**THE PORT AUTHORITY OF NEW YORK AND NEW JERSEY
TWO MONTGOMERY STREET - 1st FLOOR
JERSEY CITY, NJ 07302**

ADDENDUM NO. 7

**TO PROSPECTIVE BIDDERS ON CONTRACT JFK-164.020 – JOHN F. KENNEDY
INTERNATIONAL AIRPORT – RECONSTRUCTION OF RUNWAY 13L-31R AND
ASSOCIATED TAXIWAYS**

SKETCH SK-E1
Addendum No. 7

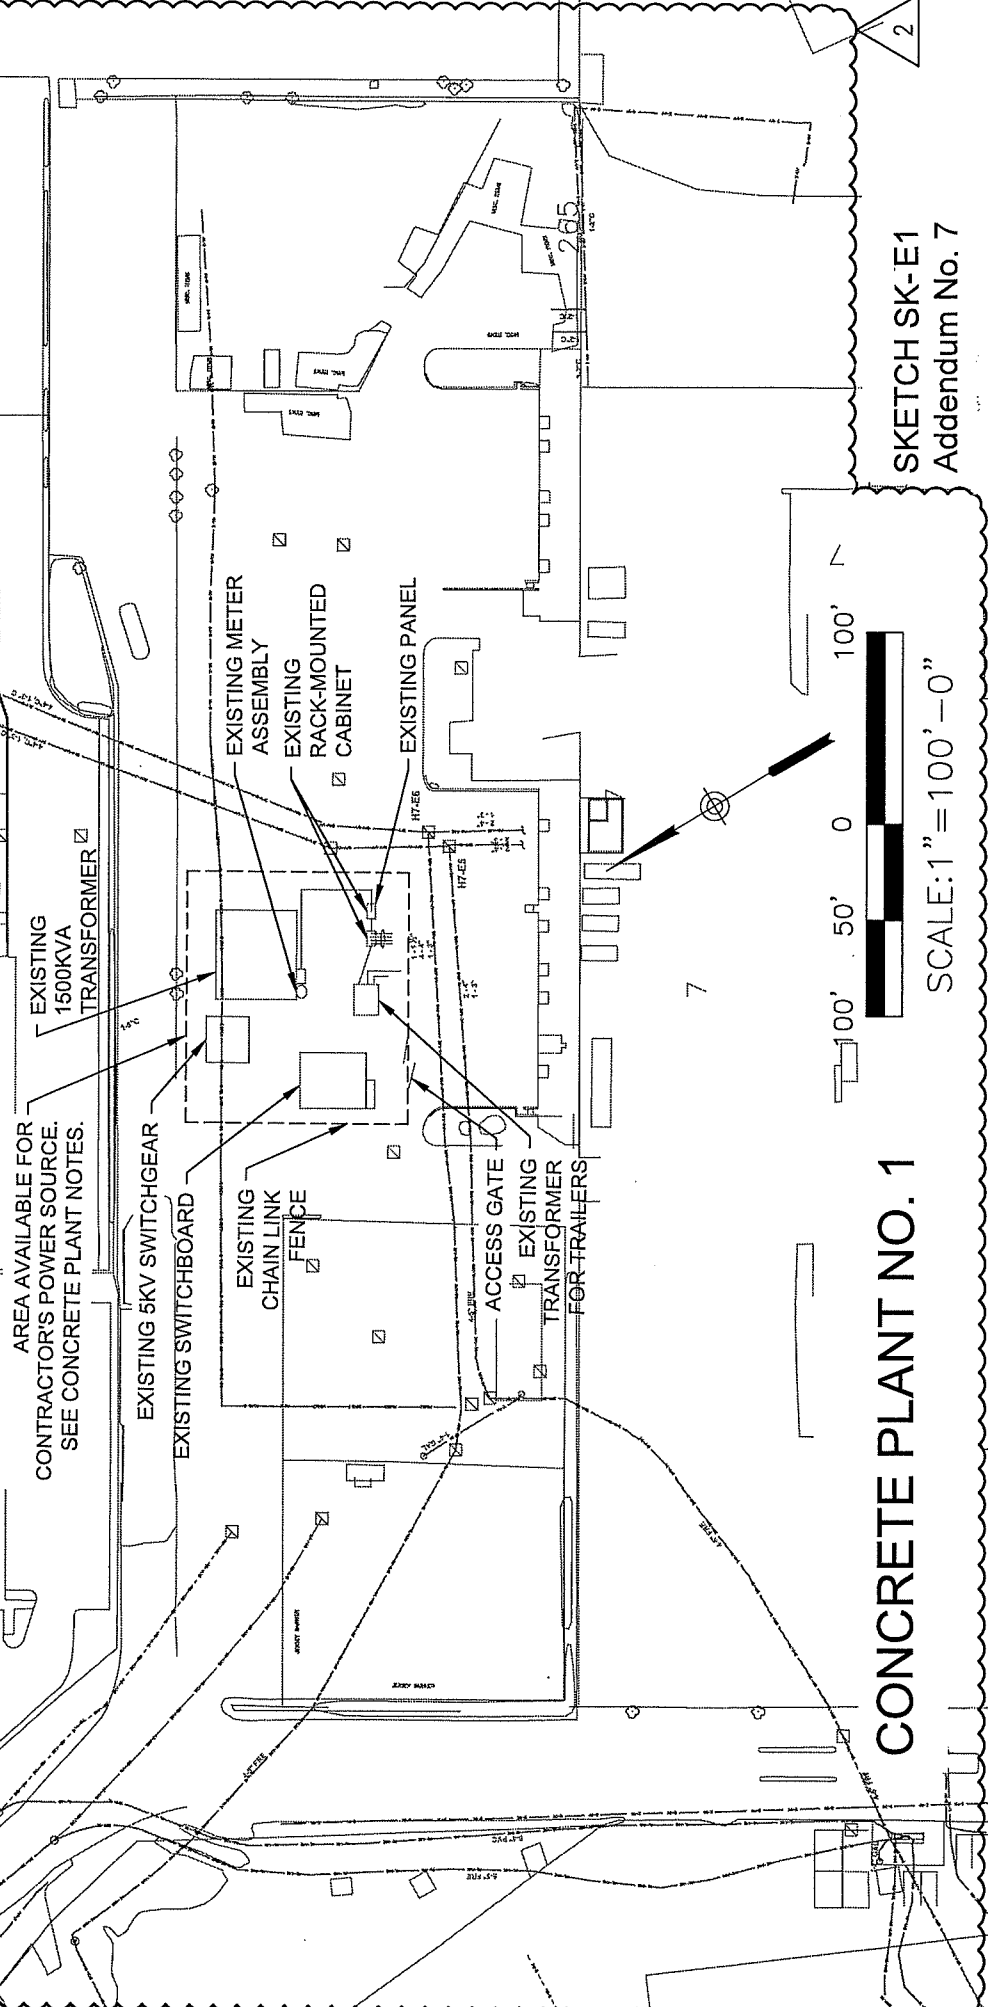
- Dwg. E103 - Revise the drawing as shown on Sketches SK-E1 and SK-E2 which are attached hereto and made a part hereof.
- Dwg. E308 - Revise the drawing as shown on Sketch SK-E3 which is attached hereto and made a part hereof.

1. FOR LEGEND, ABBREVIATIONS AND GENERAL NOTES, SEE DRAWINGS E101 AND E102.
2. UTILIZE THIS SITE FOR CONCRETE BATCH PLANT POWER. AT THIS SITE EXISTS A 3PH, 4160V FEEDER 402B WITHIN MH H7-5. ALSO EXISTS ARE A 5KV SINGLE BAY SWITCH, 1500KVA TRANSFORMER, METER, 480V, 3PH SWITCHBOARD WITH 6 DISCONNECT DEVICES, CONCRETE FOUNDATIONS, AND FENCE AT THIS SITE.
3. FURNISH AND INSTALL A TRAILER MOUNTED GENERATOR AT EACH CONCRETE PLANT SITE. GENERATOR SHALL BE CAPABLE OF SUPPLYING 1500KVA MINIMUM. COORDINATE LOCATION OF THE GENERATOR WITH THE ENGINEER.
4. PRIOR TO ACCESSING FEEDER 402B, COORDINATE A SHUTDOWN WITH THE ENGINEER 48 HOURS IN ADVANCE.
5. FURNISH AND INSTALL DEAD BREAK JUNCTIONS WITHIN MANHOLE.
